PROPOSAL FOR DRAFT AMENDMENTS TO REGULATION No. 48

(Installation of lighting and light-signalling devices)

Proposal for draft Supplement 5 to the 04 series of amendments to Regulation No. 48

Figure 1

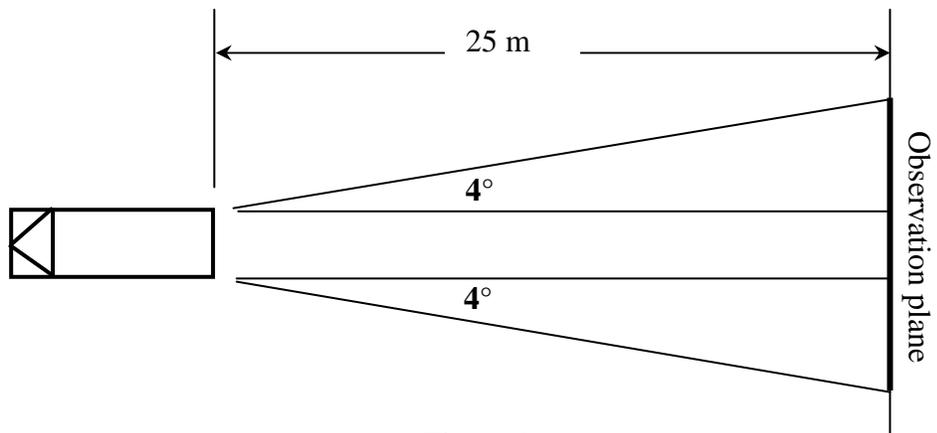
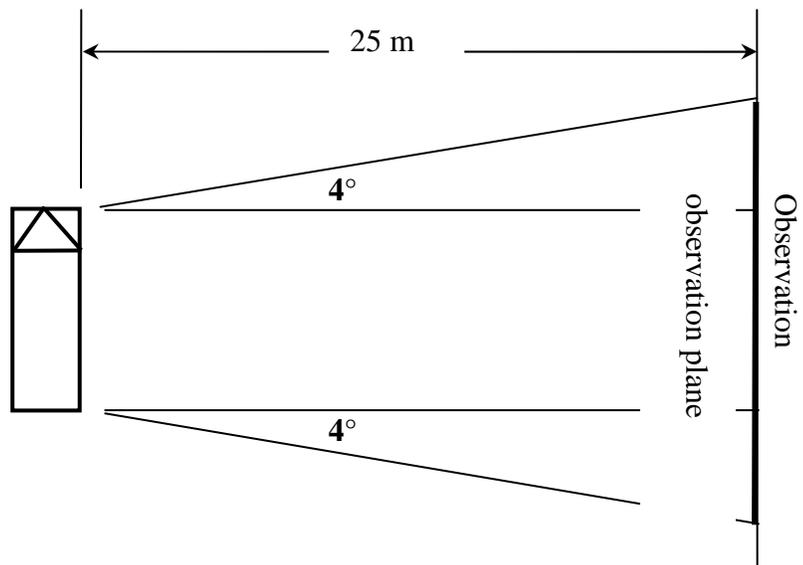
Annex 11, amend to read:

(see paragraph 6.21.5. of this Regulation)

Lastly, paragraphs 6.21.5.1.2. and 6.21.5.2.2. and Annex 11 have been amended to provide for a 4° outward observation plane requirement to the rear or side of vehicle instead of the 15° requirement, which has proven itself impractical in compliance with the 80 per cent visibility requirement due to protruding parts on a vehicle like wheel fenders and mud guards, petrol tanks, C-beam structures on trailers, etc. In this case, the 25 meter evaluation distance did not change.
